**AREA 2 FIELD SAMPLING PLAN**

**ADDENDUM TO REMEDIAL INVESTIGATION**

**FORMER FORT DEVENS ARMY INSTALLATION, DEVENS, MA**

**DECEMBER 2018**

Area 2 Figure Extents Devens PFAS RI WP - Area 2 FSP Addendum		
Former Fort Devens Army Installation Devens, Massachusetts		
<b>KOMAN Government Solutions, LLC</b> 293 Boston Post Road West, Suite 100, Marlborough, MA 01752		
	Date: 11/16/2018	Figure 1

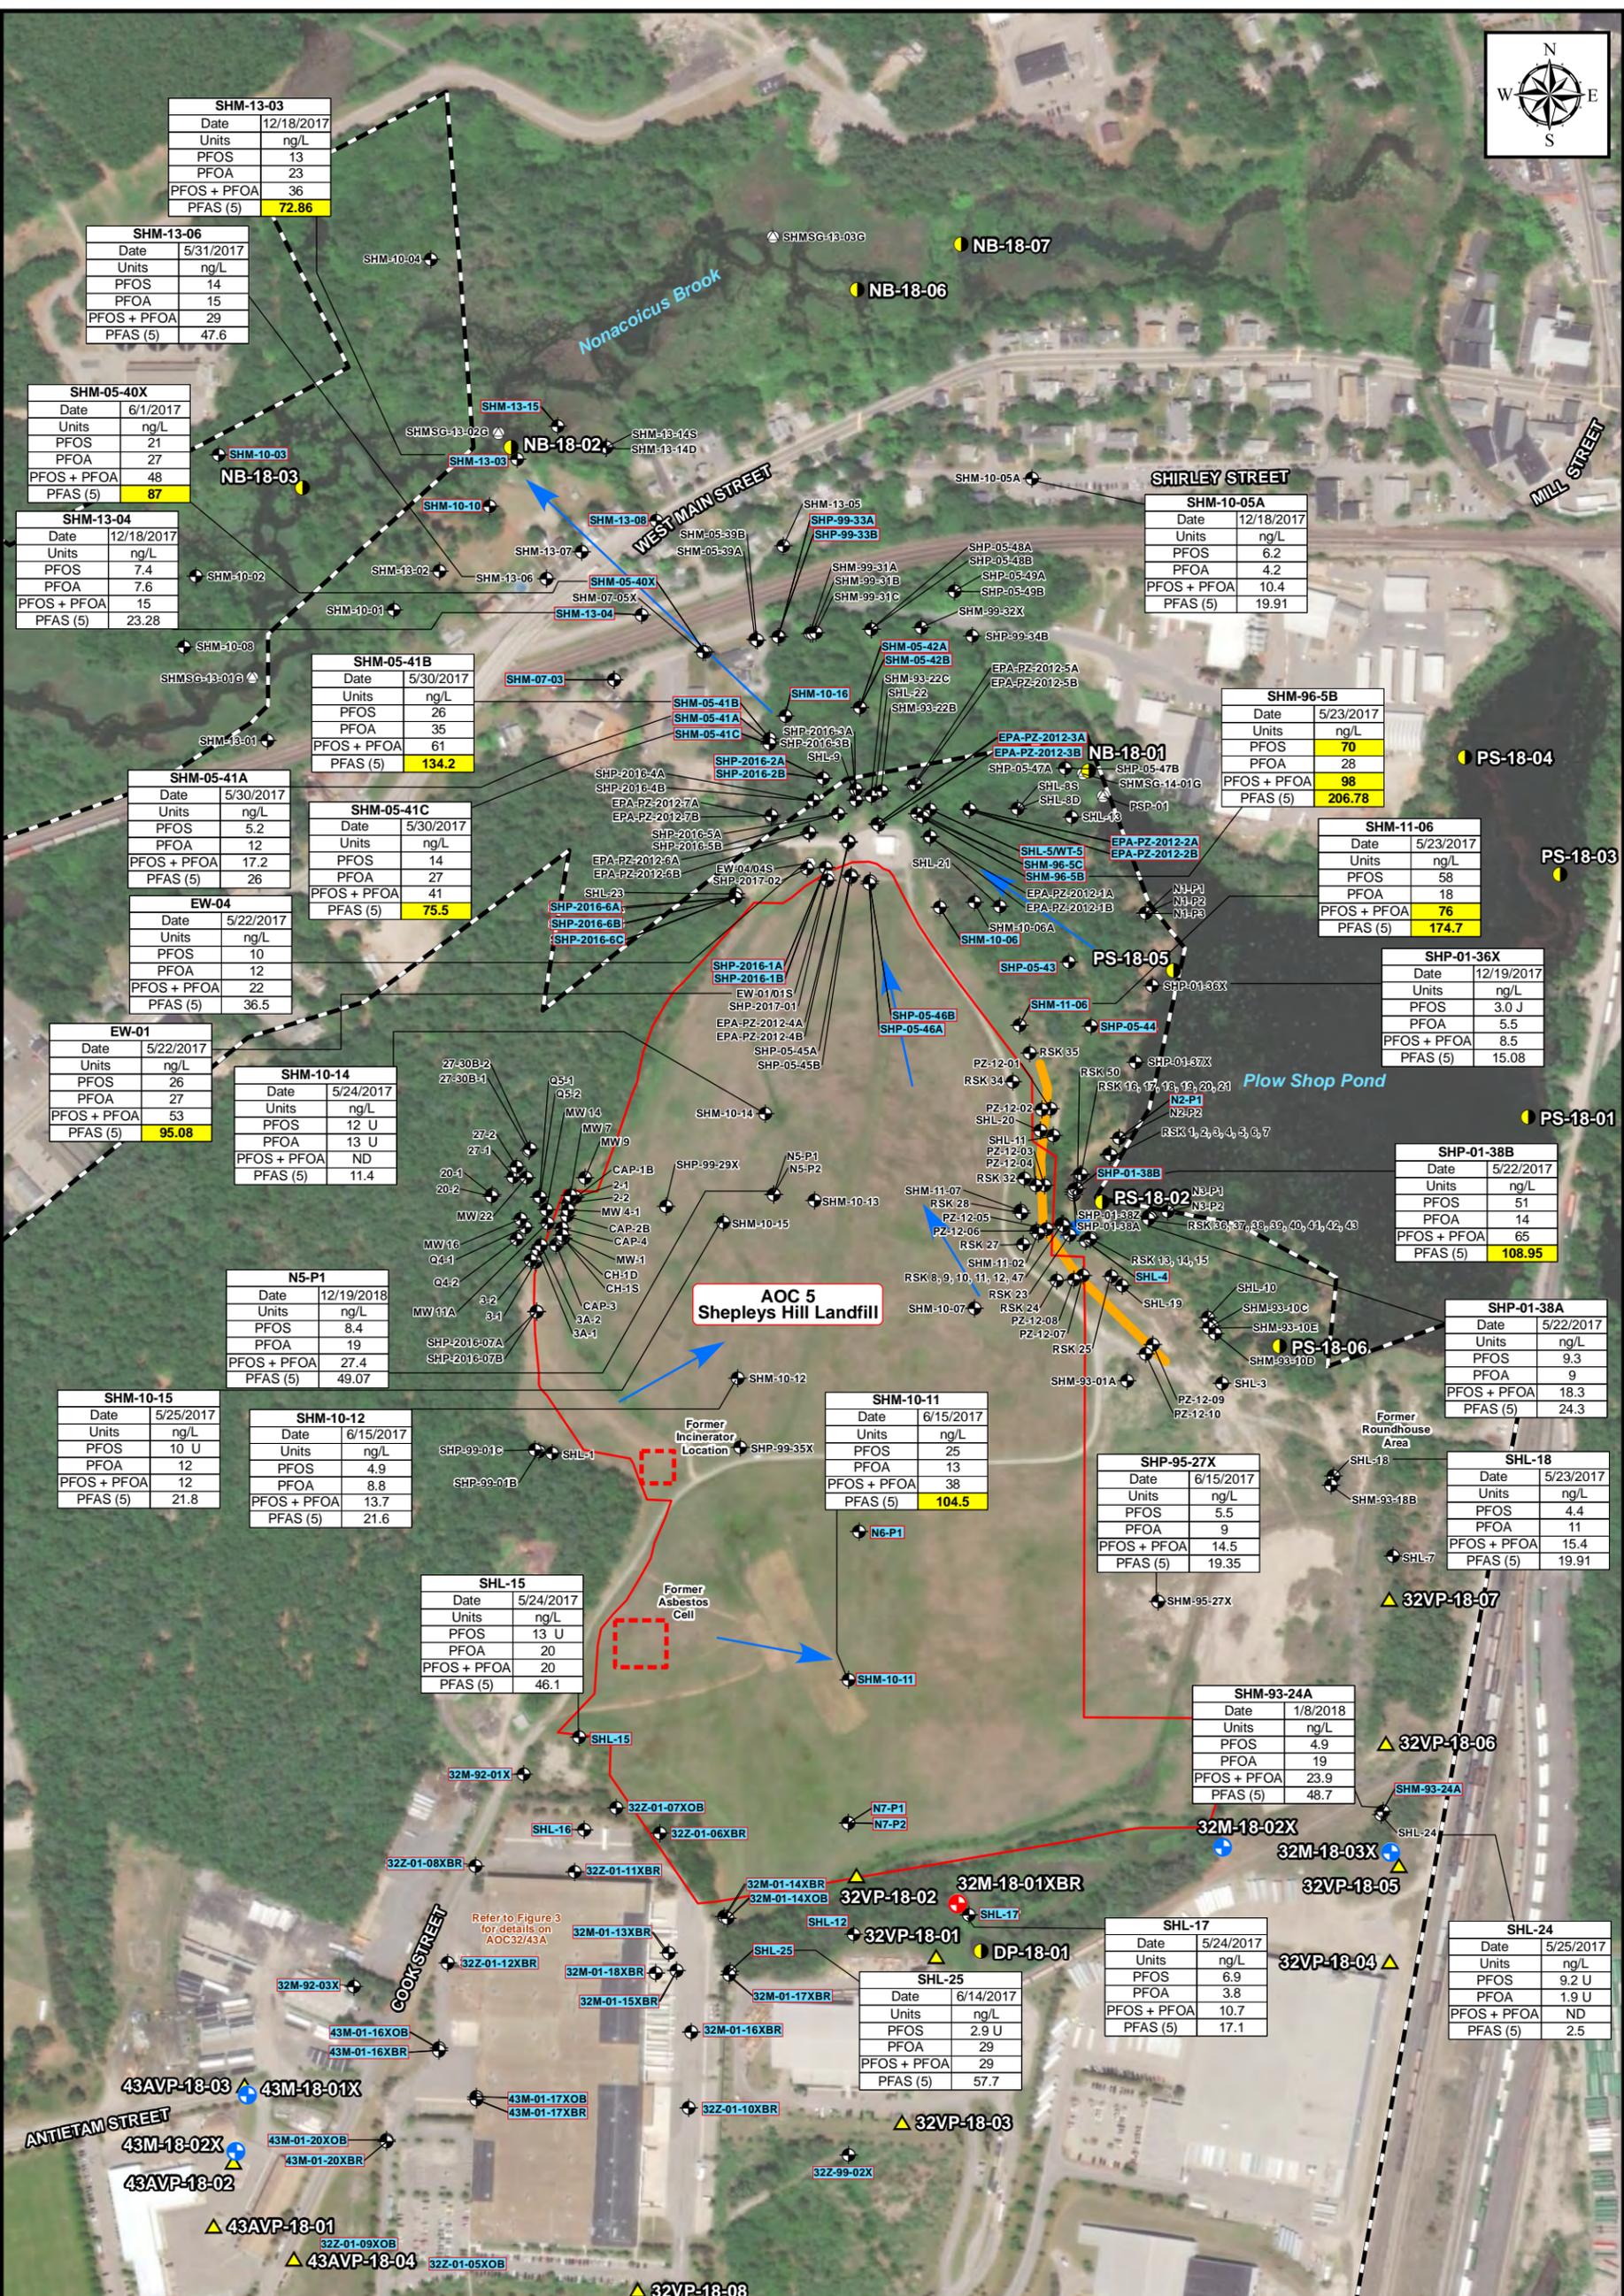
**Comment # 5:** Figure 1, Area 2, Figure Extents – Please include a symbol and label the MacPherson well on Figure 1.

**Response:** A symbol for the MacPherson water supply well will be added to Figure 1.

Figure 2

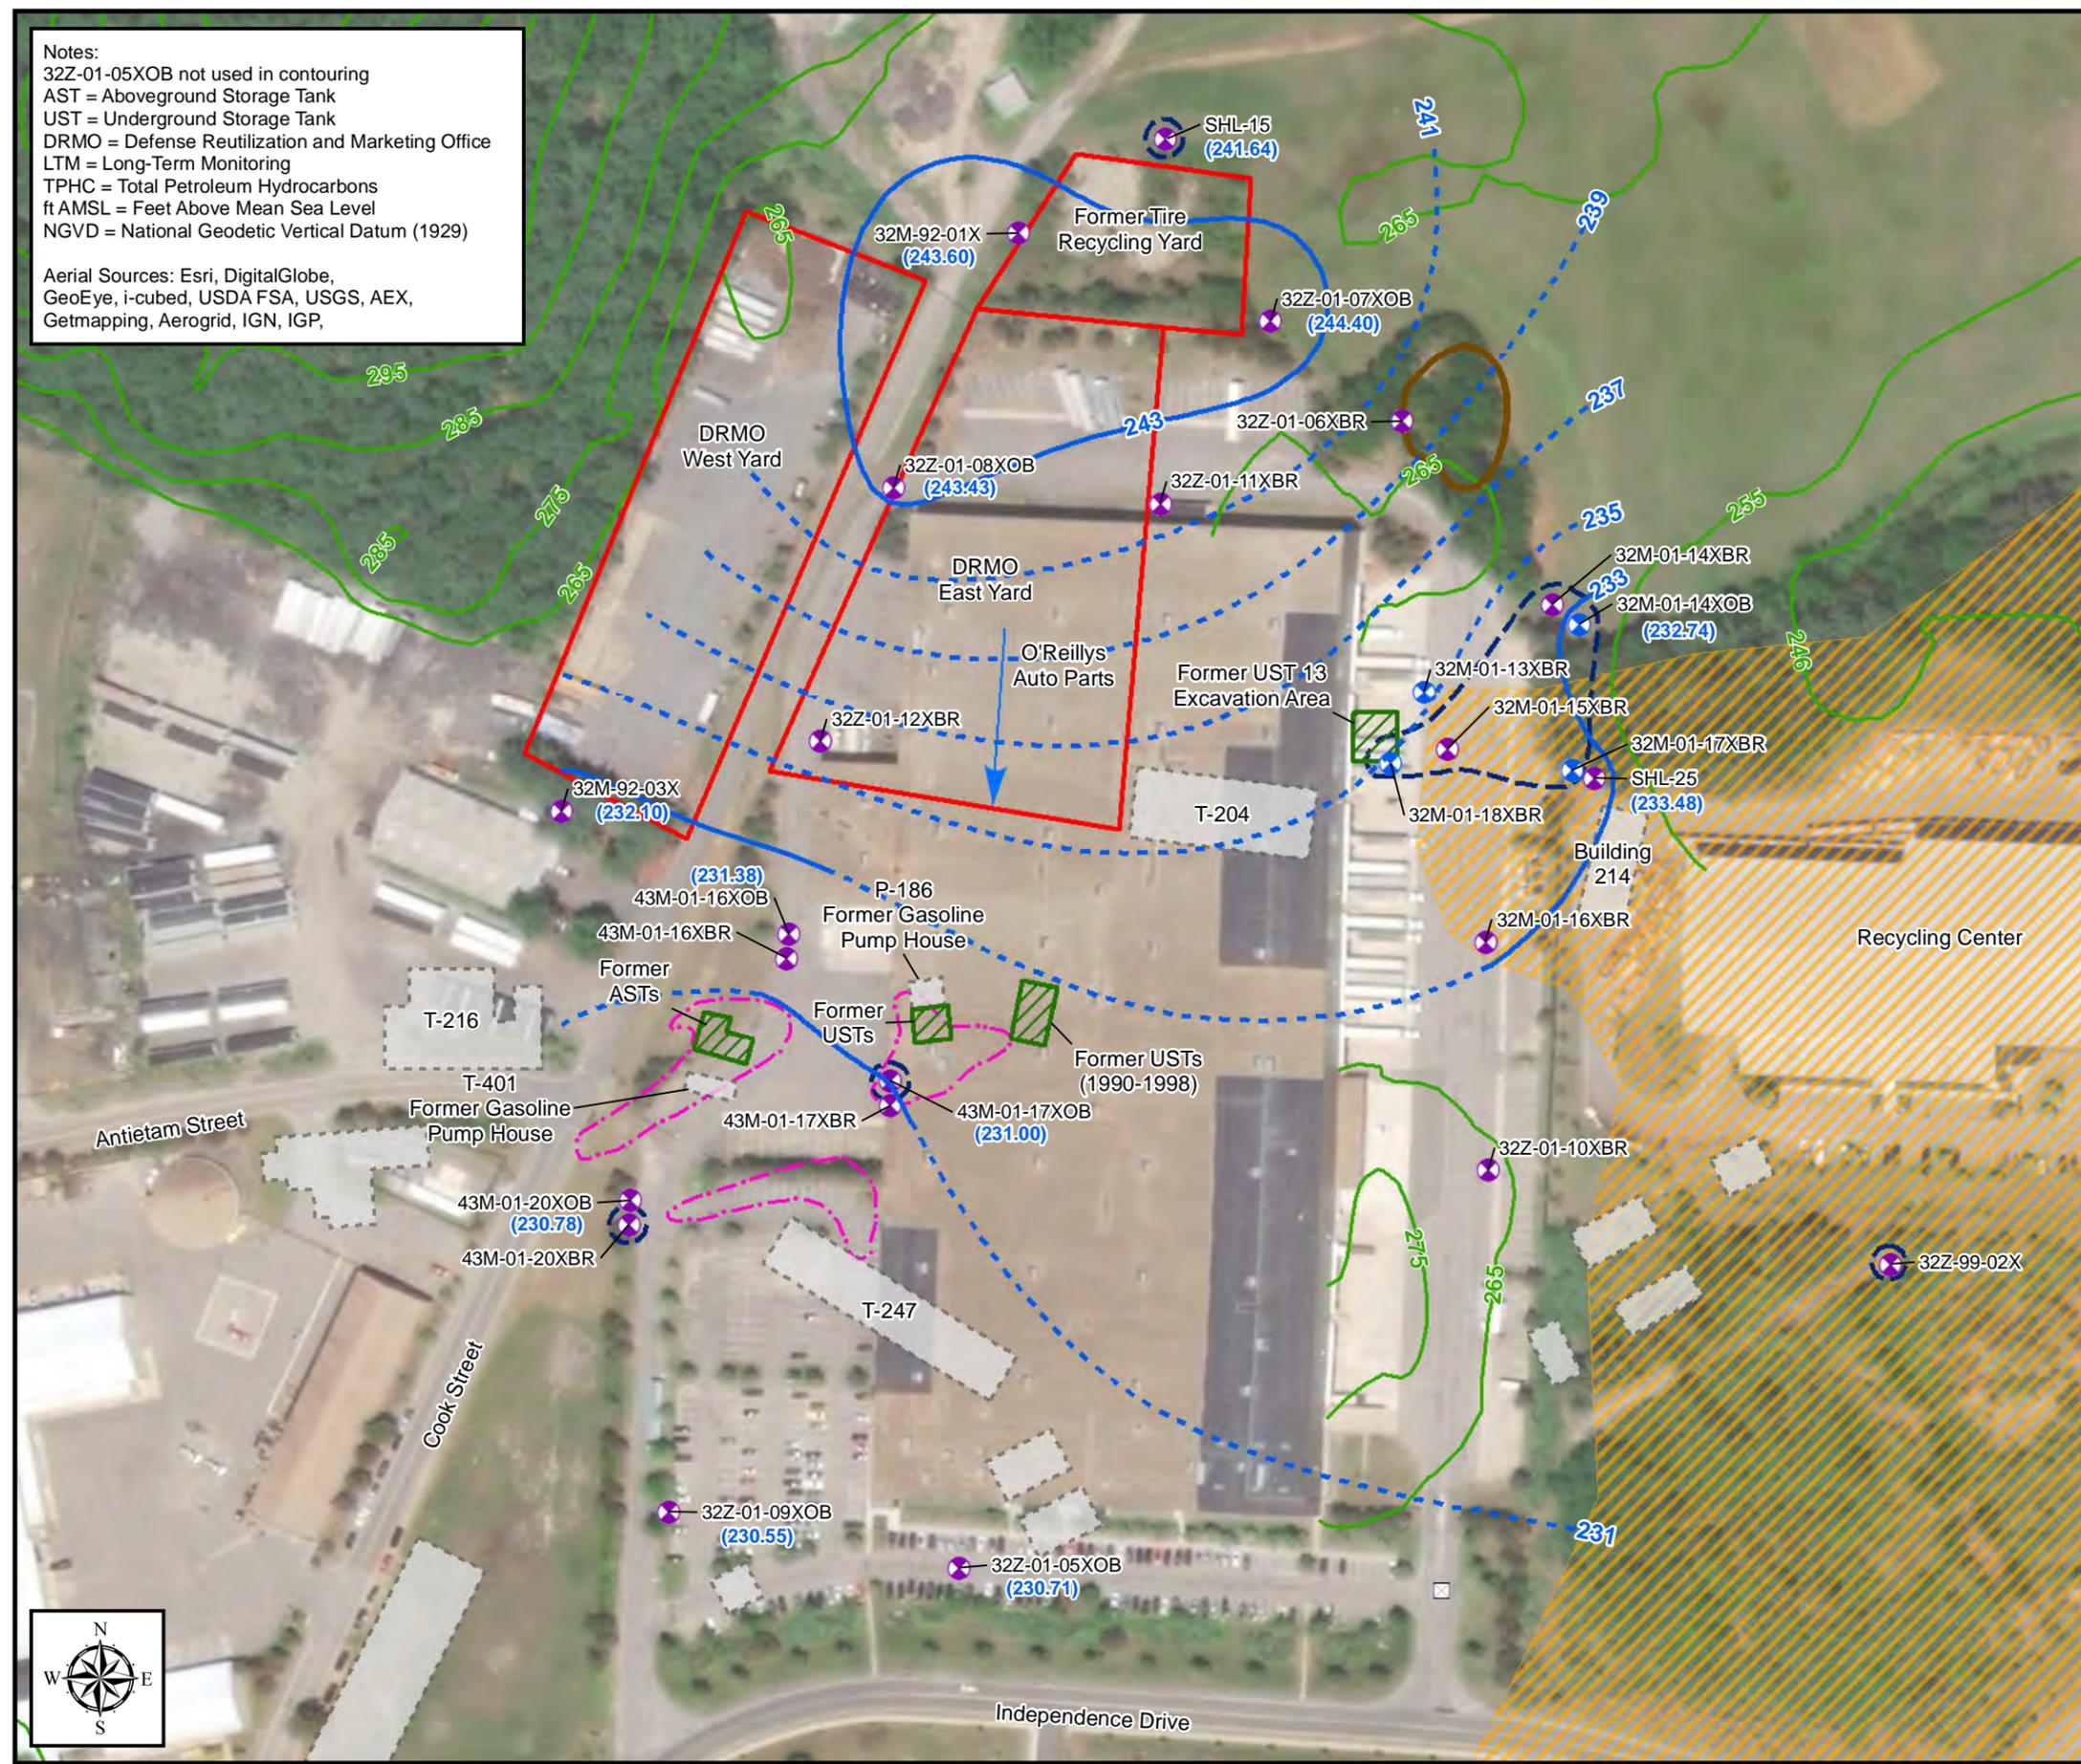
**Comment # 6:** Figure 2 and Table 1, AOC 05 – During the SI, a combined PFOA/PFOS concentration of 76 ppt (above the LHA) was detected in monitoring well SHM-11-05. In the Area 2 FSP, Army proposes to sample two nearby wells, presumably to better delineate PFAS in this area. Since these nearby wells (SHP-05-43 and SHP-05-44) are screened at approximately 50-60 feet below ground surface, it is unclear if the sampling these wells will provide sufficient data to evaluate PFAS impacts in the vicinity of SHM-11-05, screened 25-35 feet bgs. Please address.

**Comment # 7:** Figure 2, AOC32/43A and AOC 05 – The two wells previously sampled near the eastern Former Fort Devens Boundary do not provide adequate documentation of no PFAS migrating east, as both wells (SHL-18 and SHM-93-24A) are screened at approximately 15-20 feet bgs. EPA recommends that an additional vertical profile point be driven/sampled to the north of the vertical profiling locations already proposed (for AOC32/43A) to more completely evaluate the eastern migration of PFAS in this area.
